## **NUCLEAR REGULATORY COMMISSION**

Title: Advisory Committee on Reactor Safeguards  
Digital I&C Subcommittee

Date: Wednesday, February 19, 2025

# Comparison of IEEE 603-1991 and IEEE 603-2018

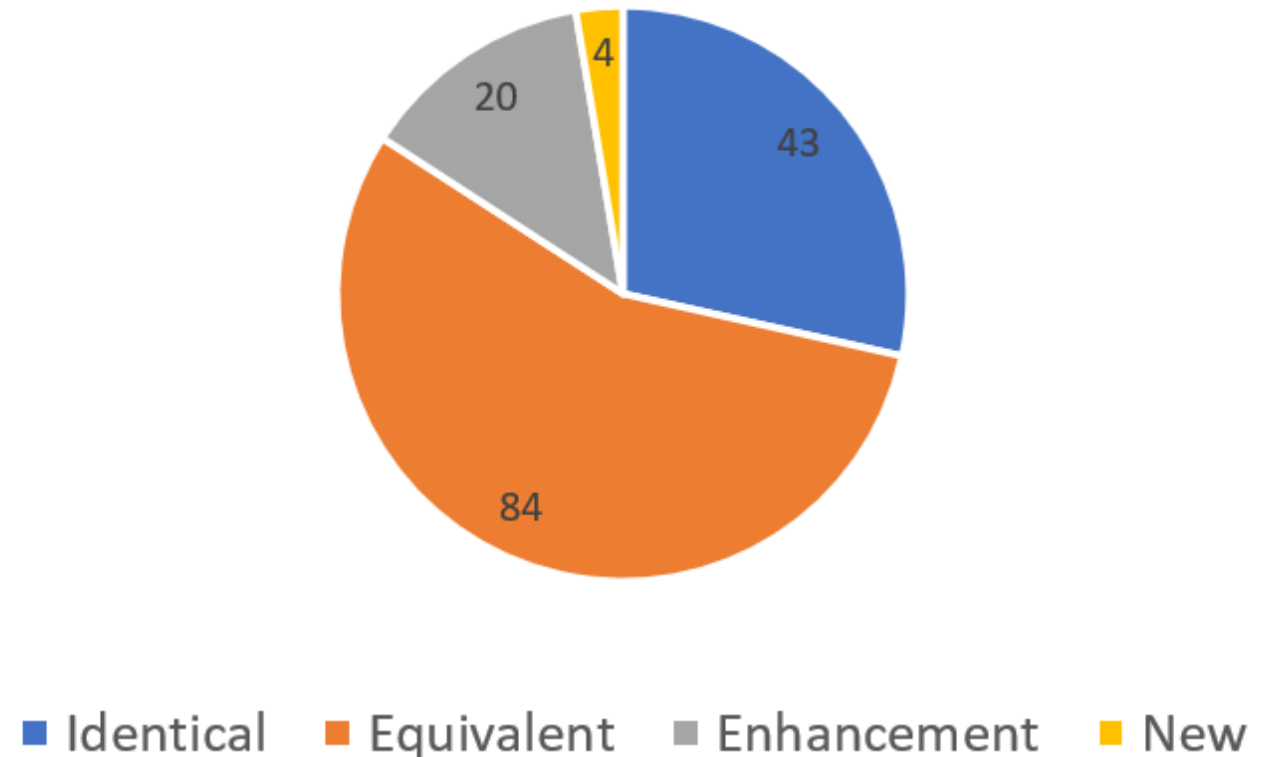
17 Also, in the following slides, we're going  
18 to be discussing the new clauses added to the  
19 document. And something to note, as you can see on  
20 the pie chart, for that comparison, the majority of  
21 the changes from the revision were mostly categorized  
22 into equivalent or identical. That was the majority  
23 of the changes. And then the four items that you can  
24 see which are new are all associated with Clause 5.16  
25 on common cause failure, which we're going to be
